FINAL
ENVIRONMENTAL IMPACT STATEMENT

F-15E BEDDOWN AT SEYMOUR JOHNSON AFB,
NORTH CAROLINA

November 18, 1988

FIGURE 4.2-1
PROPOSED ACTION
NOISE MAP-BASE

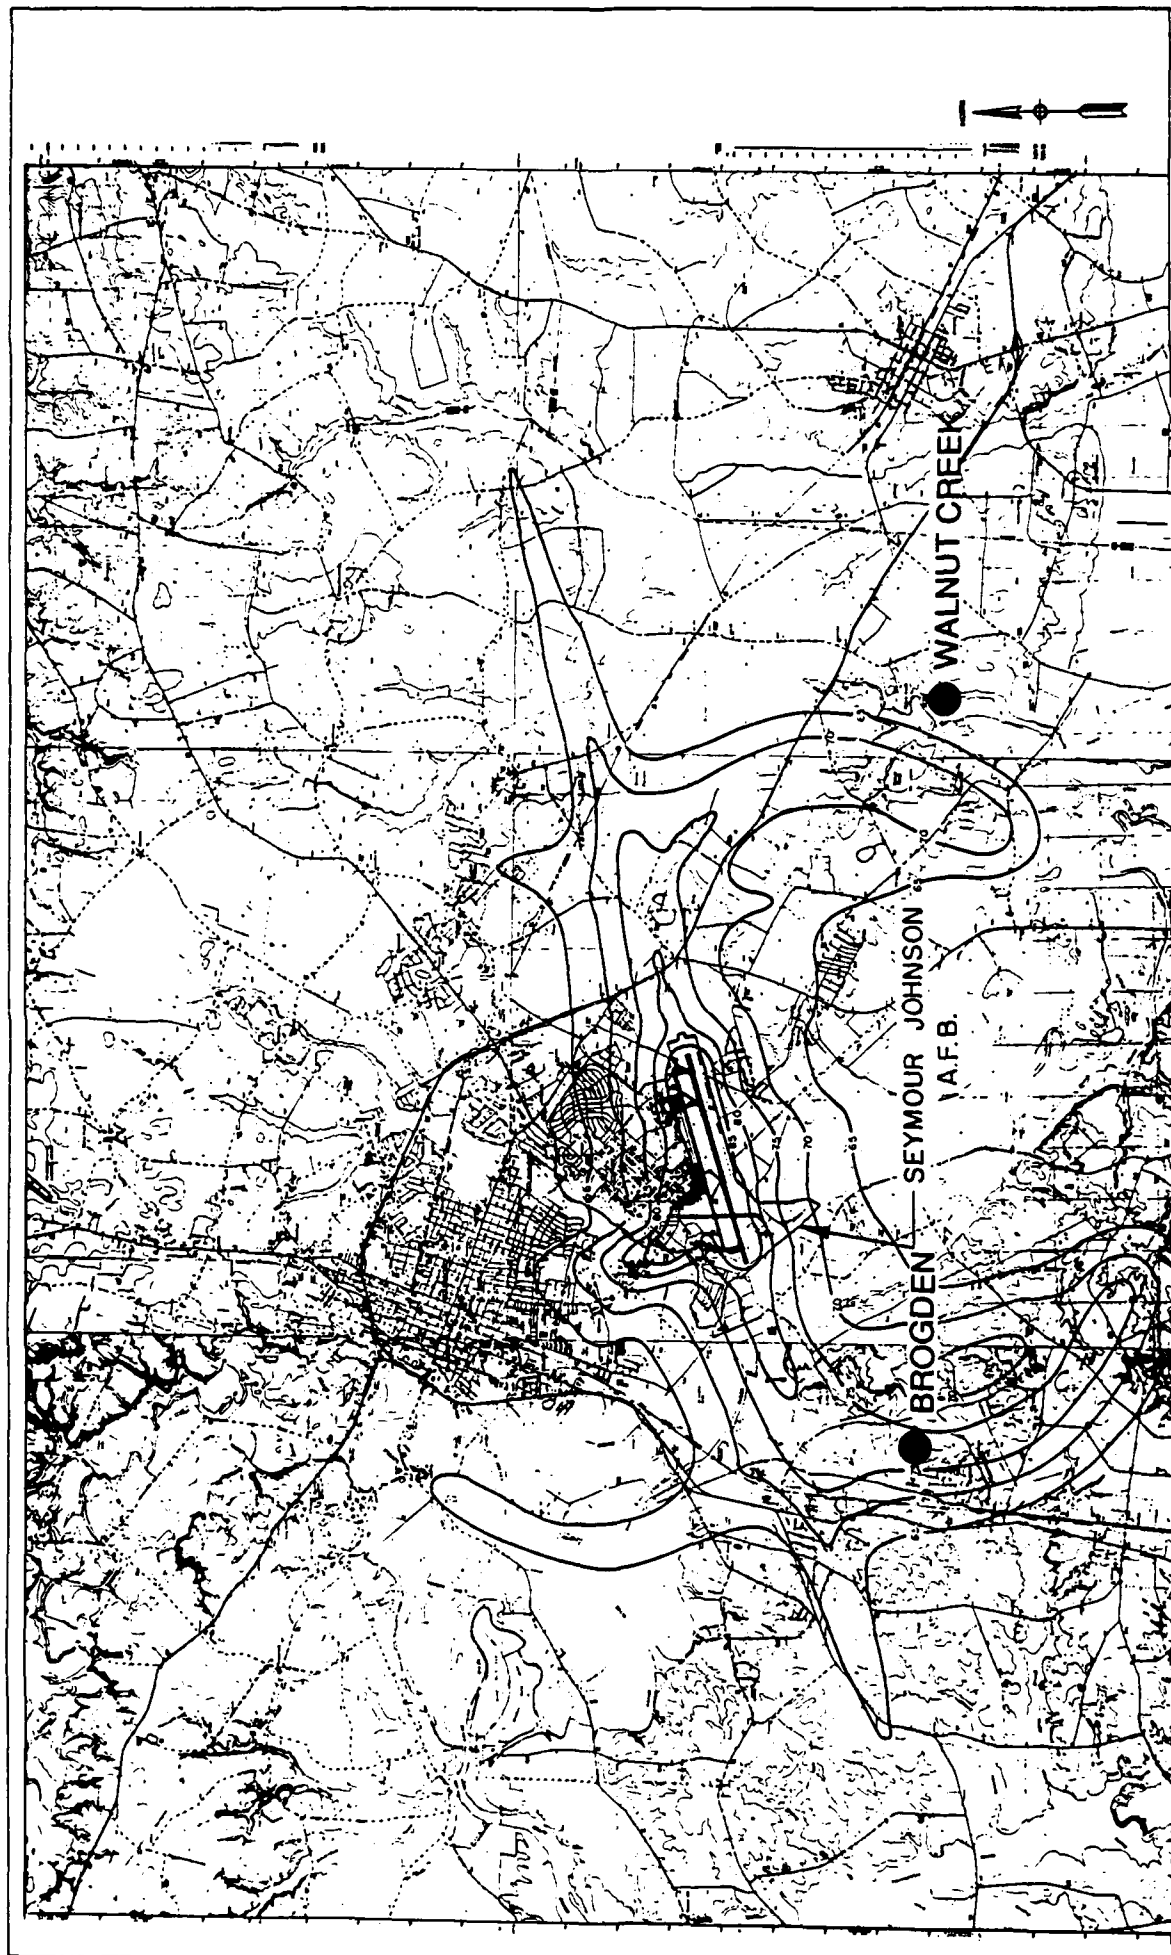
● Approximate locations of "worst case" increases in sound level due to the proposed action.

18. p. 3.4-12, 3rd paragraph, last line: Change Figure 3.0-1 to 3.0-2.
19. p. 4.2-2, Figure 4.2-1: See revised Figure in this section.
20. p. 4.2-4, 2nd paragraph, 3rd line: Change 38 to 14.
